**GOVERNMENT OF INDIA  
NORTH EASTERN COUNCIL SECRETARIAT  
NONGRIM HILLS, SHILLONG – 793003**

**Subject: Forwarding of Inspection Report.**

**Report of the inspection carried out on 18/02/2018 for the NEC funded project "Construction of Outdoor Stadium at Rijo Ground, Daporijo, Upper Subansiri District, Arunachal Pradesh".**

View of Gallery

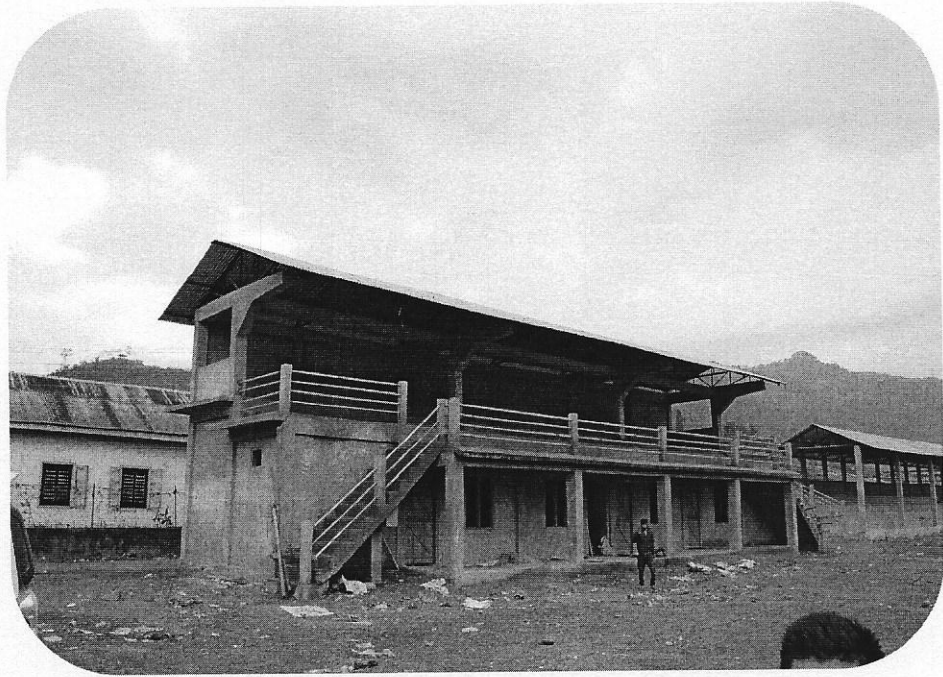
Sl. No.	Scope of Work as per Administrative Approval	Approved cost of NEC (in Rs.)	Observations & Remarks
1.	RCC covered Gallery (320M x 5.30M).	1,93,17,440	<ul style="list-style-type: none"><li>• The Consultants had inspected the site and found that the total length of the gallery constructed at site till date was 144m and a length of approximately 176m was still pending. The executing agency informed that the remaining length of about 176m would be completed as soon as they received the final installment. It could be seen during inspection that the galleries adjacent to the rostrum had been constructed, fixing of truss and CGI Sheet Roofing had been done; sitting area inside the galleries, erecting of columns and plastering works had been done. Finishing works such as painting works was still pending.</li><li>• The galleries opposite to the rostrum were still under construction and it was found that the excavation works, laying of footing, erecting of wall in all four sides of the galleries had been done. Erecting of reinforcements for columns and filling of earth for sitting area were in progress.</li><li>• The inspection team could not give any comments on the size and reinforcements used for columns at site because the detail drawings were not provided in the approved DPR.</li><li>• The Implementing department should complete the project as per specification mentioned in approved DPR.</li></ul>

- During inspection it could be seen that the works were in progress. The Implementing department had constructed galleries with a combined length of about 144meters and a length of approximately 176m was still pending. The galleries adjacent to the rostrum had been constructed, fixing of truss and CGI Sheet Roofing had been done; sitting area inside the galleries, erecting of columns and plastering works had been done. Finishing works such as painting works was still pending. The galleries opposite to the rostrum were still under construction and it was found that the excavation works, laying of footing, erecting of wall in all four sides of the galleries had been done. Erecting of reinforcements for columns and fill of earth for sitting area were in progress.

- The Implementing department should complete the project as per specification mentioned in approved DPR.
- As already observed, a number of works are still pending and the major one is the RCC covered gallery (55% of the work is remaining). The implementing agency should ensure speedy completion within the overall sanctioned amount. If the UC's, progress report and other document submitted by the State Government are in order, the concerned Sector should take a call on expediting fund release since the project is already more the 3 years old.
